AEROSTAR SERVICE BULLETIN #133

AUG 23 1994

All Baskets with 4-Point Aluminum Superstructures

Figure 1 Cable Redundancy Installation

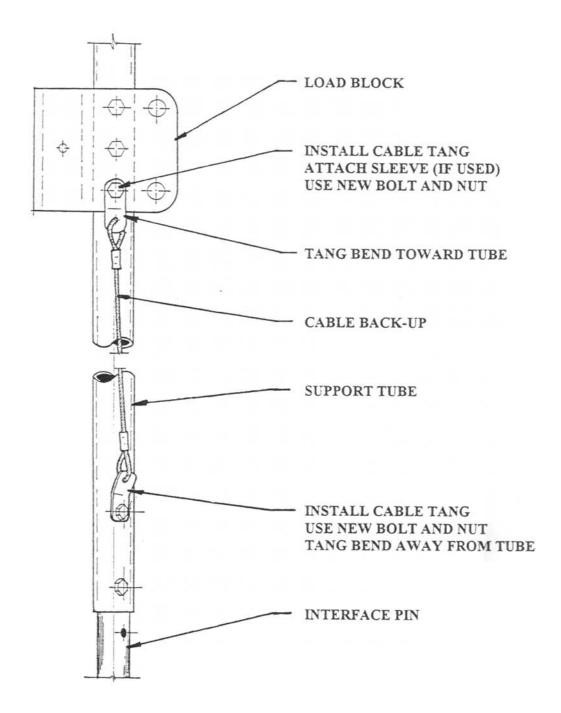
Aluminum support tubes on 4-point systems may be susceptible to damage normally hidden by the load block. Contributing factors may include metal fatigue and unusual torque forces on load fittings induced during inflation tie-off and/or tether operations. This can result in highly concentrated localized stresses in the support tube.

In a very limited number of instances one or more support tubes have failed at the bottom bolt hole of the load block fitting. The occurrence is more common in high-wind inflation tie-off, or high-wind tether situations which exert a rotational torque on the load block fittings. Further investigations have revealed evidence of fatigue fractures and fretting around the bolt hole prior to failure.

A cable back-up redundancy system is to be installed in accordance with the enclosed procedure and utilizing a factory supplied parts kit.

For systems without upright covers (leather or cordura), a cordura sleeve will be provided to cover the support tube and cable.
